Final Comments
Revised from the August 21, 2000 Submittal at Public Hearing
on the Draft EIS for the Construction and Operation of an Independent Spent Fuel Storage
Installation on the Reservation of the Skull Valley Band of Goshute Indians and the Related
Transportation Facility in Tooele County, Utah, June 2000

by Robin Jenkins, Scientist
September 12, 2000

Skull Valley Area: Wilderness Proposals

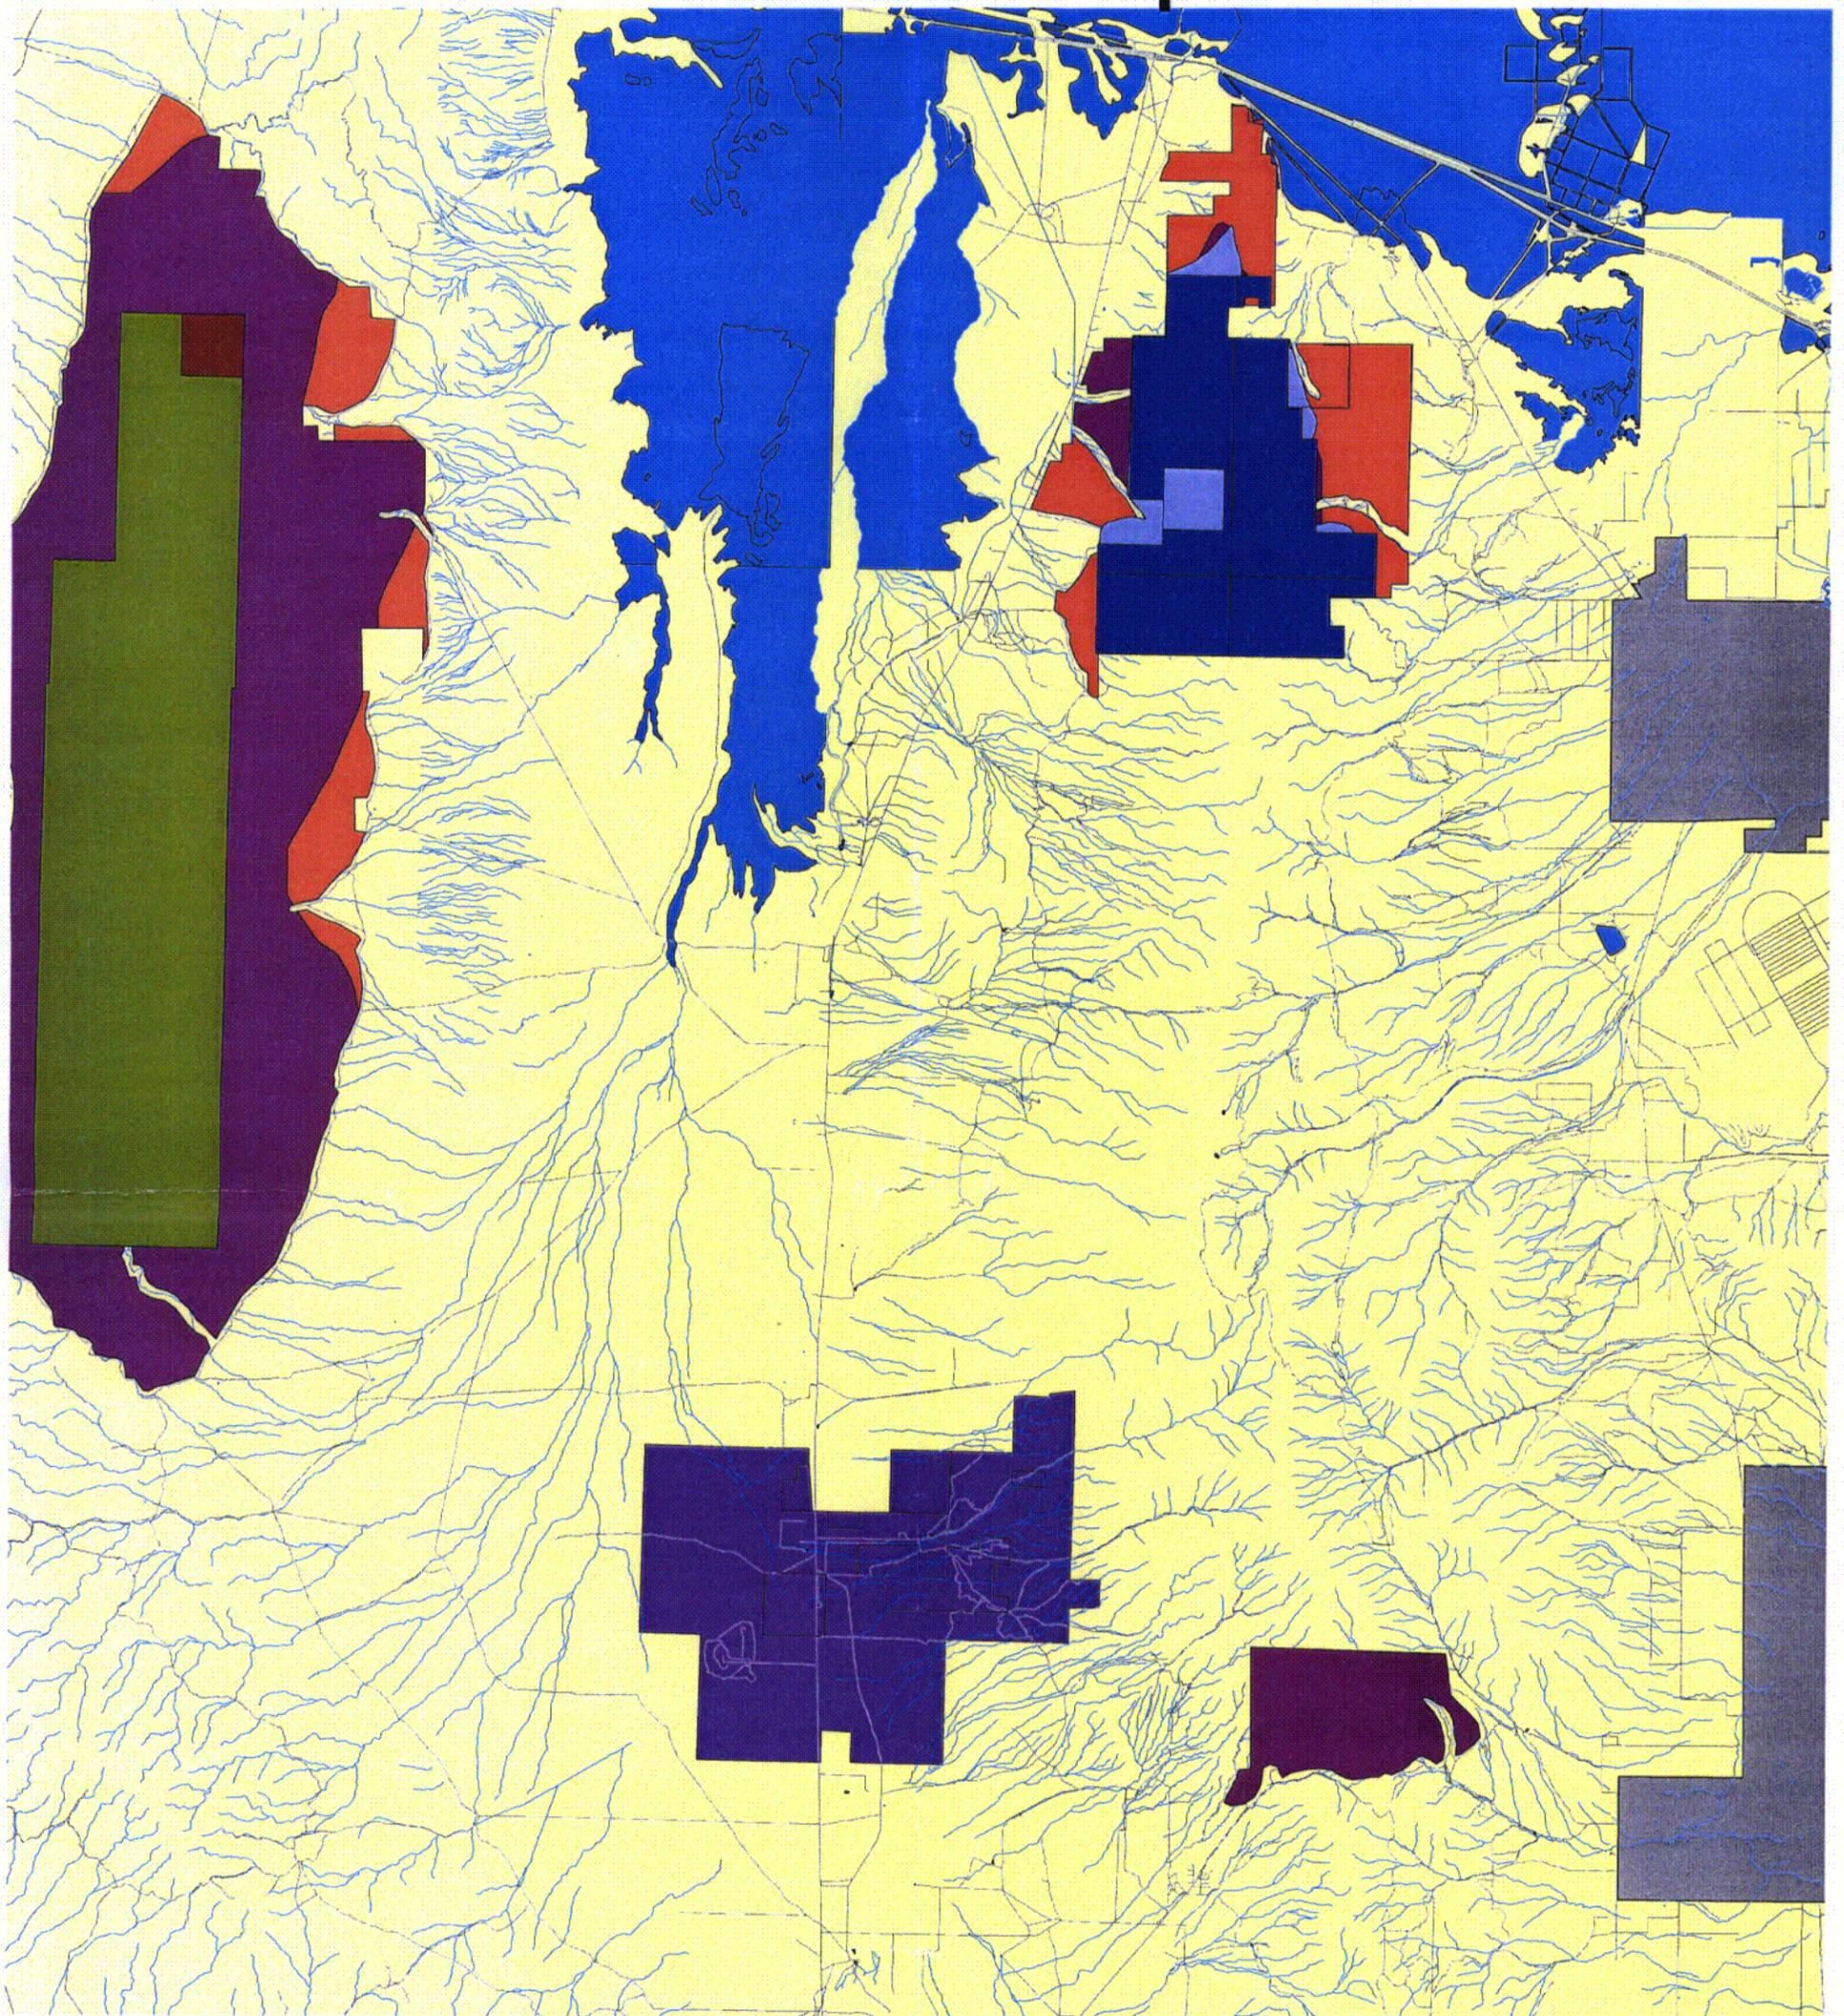
The proposed rail spur appears to cut through the BLM's ACEC (see enclosed map). Also, the Division of Water Quality has authority to regulate threats or impacts to surface and groundwater. How will the ACEC be protected against adverse impact?

Hydrography and Shallow Groundwater Characteristics of Skull Valley

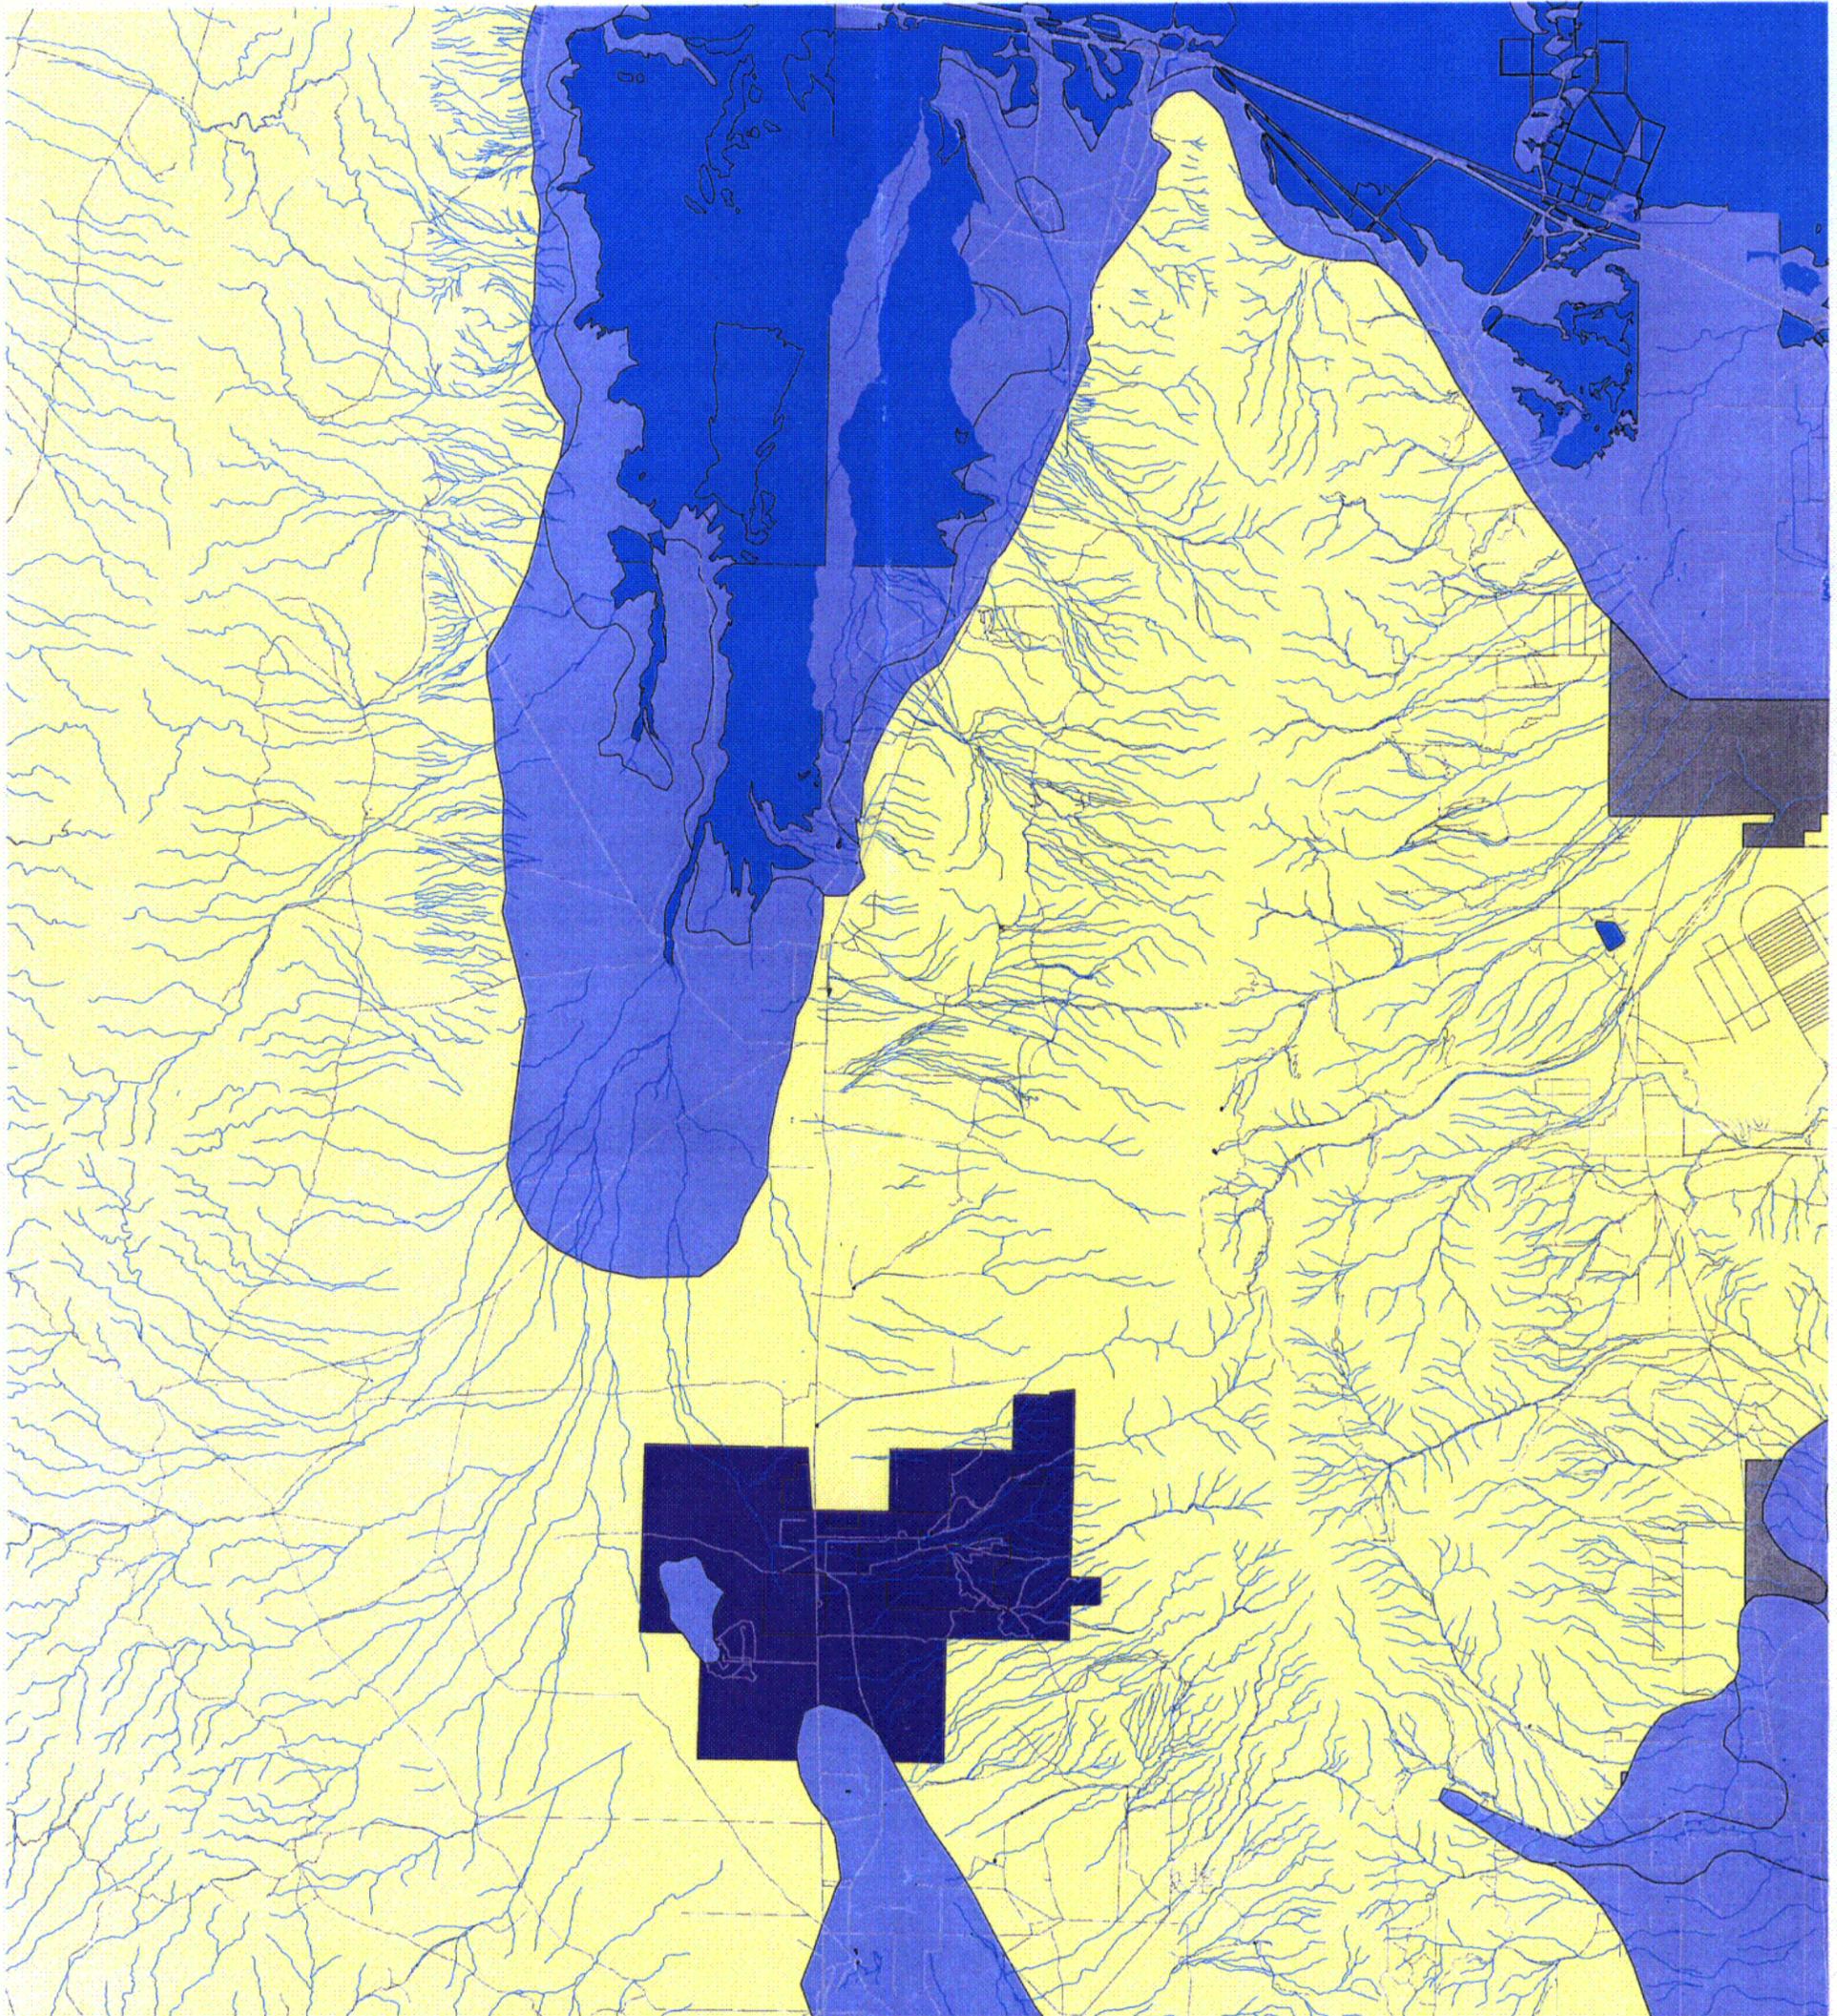
The statement is made that Figure 3.3 shows drainage channels and springs, yet it fails to show the "salient" features, mentioned in later sections, that are significant to this proposal. These salient features include the BLM's Area of Critical Environmental Concern (ACEC), Indian Hickman Springs (the aqueduct that transports water from Indian Hickman Spring) and the Goshute Reservation outline. The Reservation outline would show that one of the tribe's sources of water (Indian Hickman Creek, page 3-26, line 5), which PFS alludes to requiring for the facility, does not originate on the reservation and is therefore subject to adjudication, not indiscriminate, unquantifiable use as proposed in this DEIS.

There must be maps showing these important “salient” features, and clearer discussion of these features and water resources.
